V2500-A1 PROPULSION SYSTEMS SERVICE BULLETIN

This document transmits the Initial Issue of Service Bulletin EV2500-73-0175

V2500-ENG-73-0175

ENGINE – FUEL AND CONTROL – PROVIDE NEW RIGHT AND LEFT PRESSURE CONTROL MANIFOLDS

Location of pressure control manifolds
Fig 1

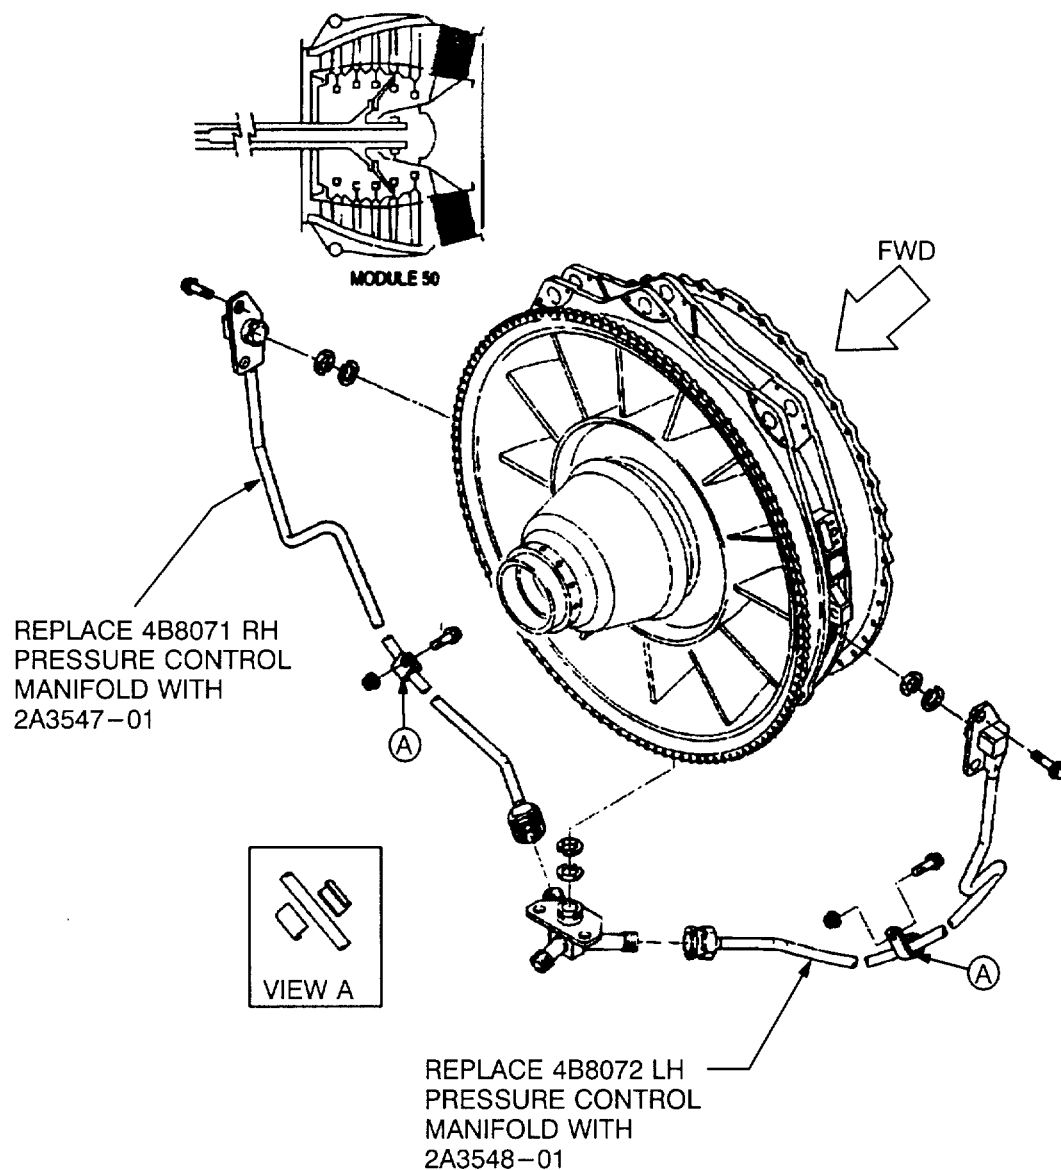
Replace the right and left pressure control Manifold Assemblies

- (1) Replace the Right Hand Pressure Control Manifold Assembly, PN 4B8071 with PN 2A3547-01 by the procedure specified in Reference 5 Engine Manual, 72-00-50-420-005-A00.
- (2) Replace the Left Hand Pressure Control Manifold Assembly, PN 4B8072 with PN 2A3548-01 by the procedure specified in Reference 5 Engine Manual, 72-00-50-420-005-A00.

Family tree - Left and right pressure control manifolds Ref catalog sequence no.
73-22-51 Fig 01 item 050 and 180
Fig 2

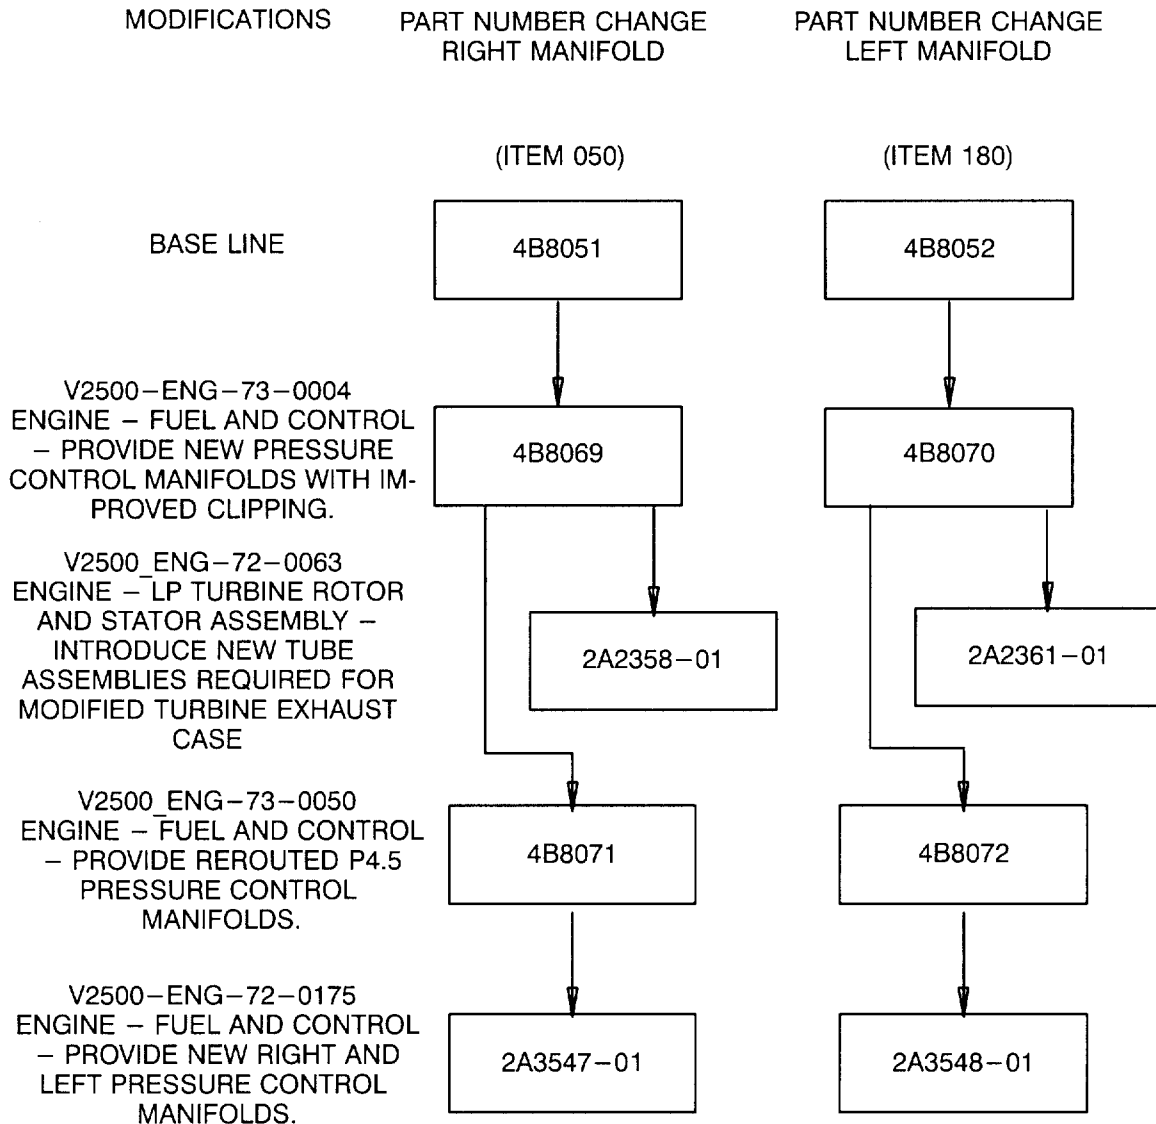
FIG ITEM NO.	NEW PART NO.	QTY	PART TITLE	MAT	OLD PART NO.	INSTR DISP
01050	2A3547-01	1	Manifold, RH press Control	-	4B8071	(2) (A) (L)
01055	-	1	Sleeve	-	4B8069-01	(L)
01055	AS3268-082	2	Sleeve	-	-	(D)
01057	AS15769	1	Ferrule	-	-	(D)
01058	AS15701	1	Nut, Tube Coupling	-	-	(D)
01059	AS15777	1	Wire, Thrust	-	-	(D)
01180	2A3548-01	1	Manifold, LH Press Control	-	4B8072	(2) (A) (L)
01183	-	1	Sleeve	-	4B8070-01	(L)
01185	-	1	Sleeve	-	4B8069-01	(L)
01185	AS3268-082	2	Sleeve	-	-	(D)
01186	AS1569	1	Ferrule	-	-	(D)
01187	AS15701	1	Nut, Tube Coupling	-	-	(D)
01189	AS15777	1	Wire, Thrust	-	-	(D)
